MAPLE MEDICAL OFFICE JSP21-33

Matter for Consideration at the request of AJSS Property, LLC, for approval of the Preliminary Site Plan and Stormwater Management Plan. The subject property is approximately 0.42 acres and is located east of Novi Road and south of Fourteen Mile Road in the RA, Residential Acreage, Zoning District with a Planned Unit Development (PUD). The Maples of Novi PUD Agreement & Area Plan was recently amended to allow this site to be reviewed under the B-1, Local Business, Zoning District. The applicant is proposing to remove the existing tennis courts on the site and construct a 2,558 square foot medical office.

PLANNING REVIEW

Planning Review MAPLE MEDICAL BUILDING

PRELIMINARY SITE PLAN

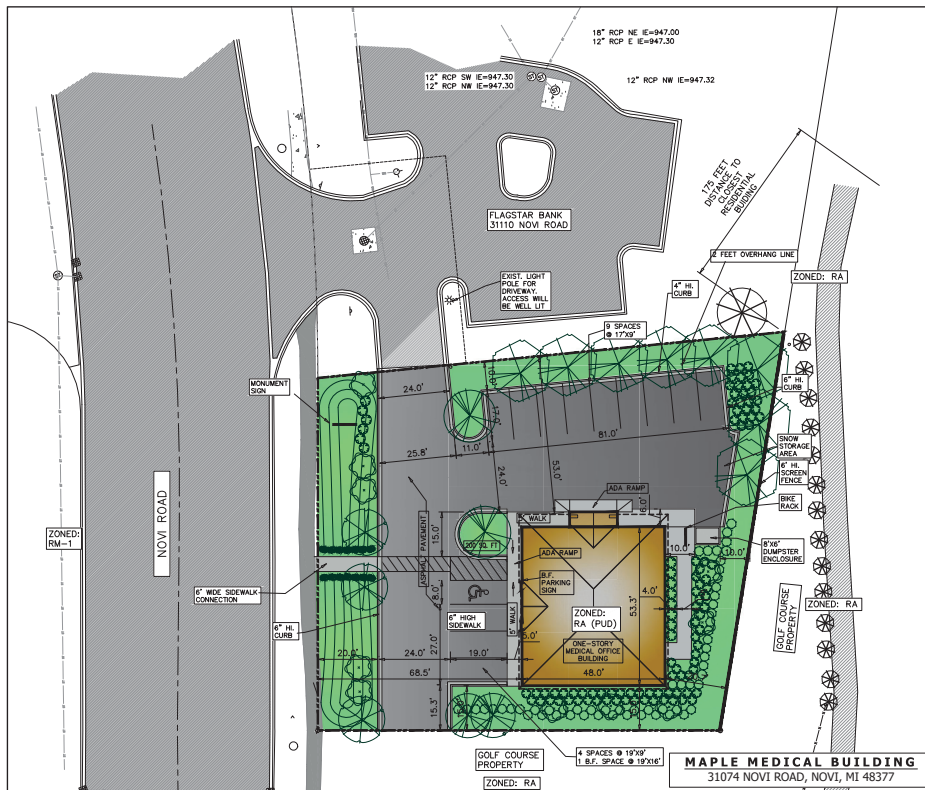
Parking Space & Maneuvering Lane Dimensions (Sec. 5.3)
Response: The curb height and 2' overhang for 17' long spaces is noted on Sheet CS-01

Barrier Free Spaces (ADA standard)
Response: The location of the space has been revised and is shown on Sheet CS-01

End Islands (Sec. 5.3.12)
Response: We have provided an end island along front of the building and is shown on Sheet CS-01

Sidewalks (City Code Sec. 11-256 & 11-276 & Non-Motorized Plan)
Response: A connection to the existing sidewalk connecting building exits is shown on Sheet CS-01

Response: The island has been widened to 10 feet at back of curb and is shown on Sheet CS-01

Response: A 200 square foot island has been provided on the west side of the building as is shown on Sheet CS-01

Response: Van accessibility with signage is shown on Sheet CS-01

Response: A 6" clear path has been provided and is shown on Sheet CS-01

SHEET TITLE
SITE DETAILS

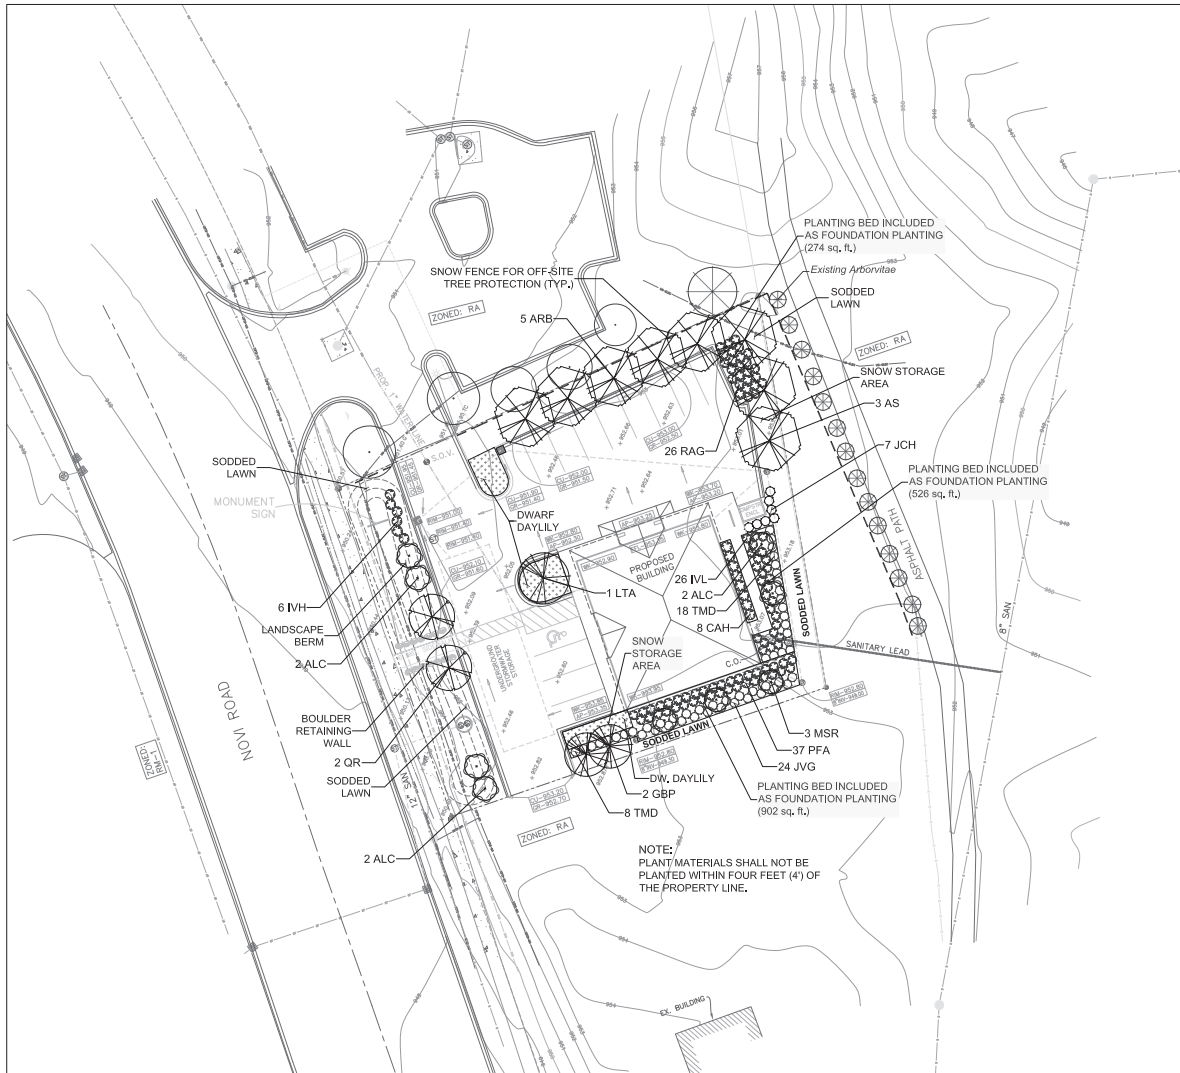
Dumpster Requirements (City Code Sec. 21-145)
Response: Details for dumpster have been provided on Sheet CS-02

Response: Details for the international symbol for accessibility pavement markings are Shown on Sheet CS-02

Response: A detail for Crosswalk pavement marking detail is shown on Sheet CS-02

PHOTOMETRIC PLAN
SCALE 1"=10'-0"

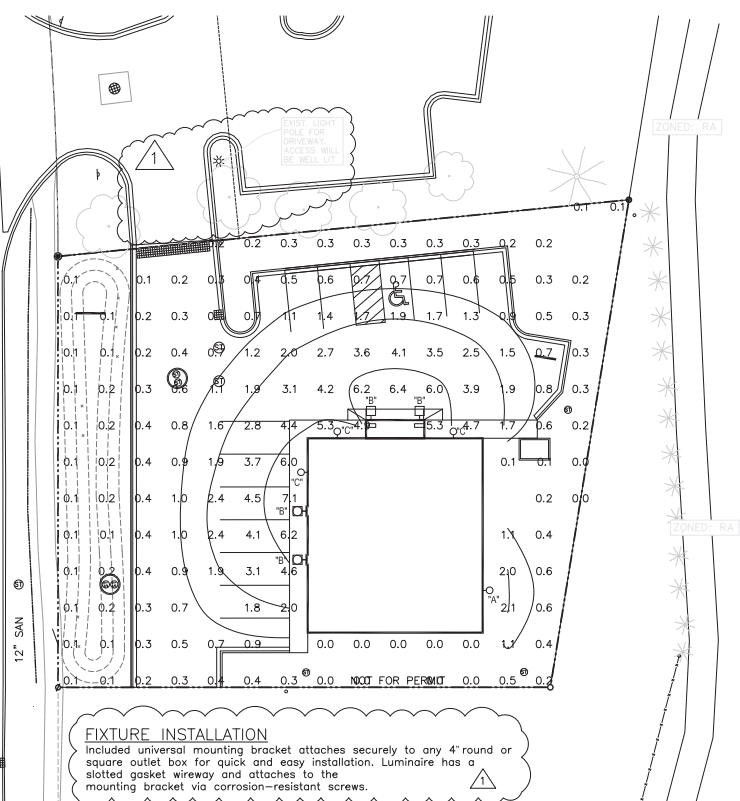
Response: Hours of operation have been provided on Sheet CS-01. Spillover information of light pole will be provided and shown on Sheet PH-1

Response: Standard notes are provided on Sheet PH-1

Response: A mounting detail for lighting fixture is shown on Sheet PH-1

Response: The average light level is shown on Sheet PH-1
